**REBUTTAL TESTIMONY OF RICHARD KUPREWICZ  
EVALUATING PG&E'S PIPELINE SAFETY ENHANCEMENT  
PLAN**

**CALIFORNIA PUBLIC UTILITIES COMMISSION  
PIPELINE SAFETY RULEMAKING  
R. 11-02-019**

**Submitted on behalf of  
THE UTILITY REFORM NETWORK (TURN)**

February 28, 2012

5 Figure 1: Pressure Cycling, MAOP = 975 psig

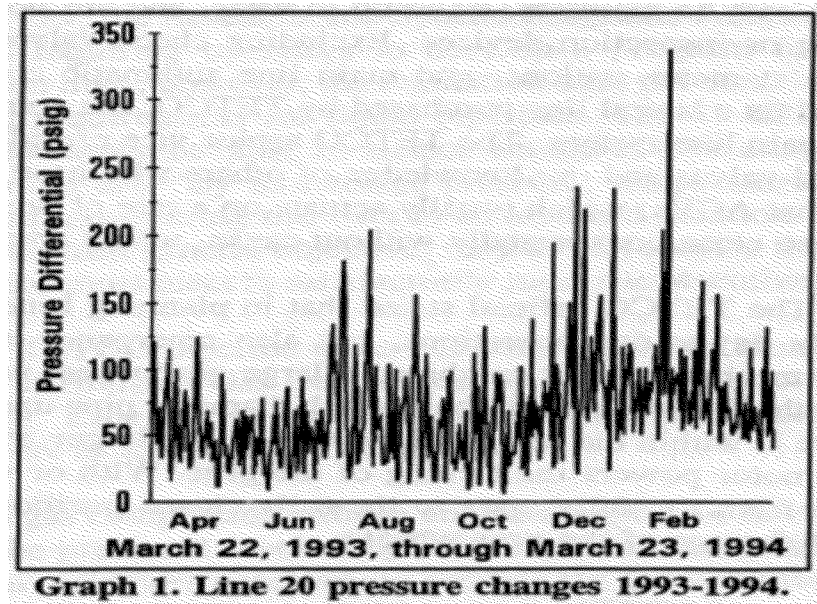
14 Low-pressure, low % SMYS, hydrotesting can leave very large imperfections in the  
15 manufactured pipe seam welds that are much more susceptible to further growth to rupture  
16 failure in a relatively short time from pressure cycling than the much smaller imperfections left  
17 in high-pressure hydrotesting. This is especially true on many gas transmission pipelines that  
18 undergo considerable variations in their operating pressure, which occurs on most gas  
19 transmission pipelines. It is a myth that gas transmission pipelines do not pressure cycle. Figure  
20 1 below is an example of a gas transmission pipeline pressure cycle spectrum (MAOP of 975

1 psig) in the public domain whose pipe ruptured from time -delayed damage many years after the  
2 damage occurred.<sup>1</sup>
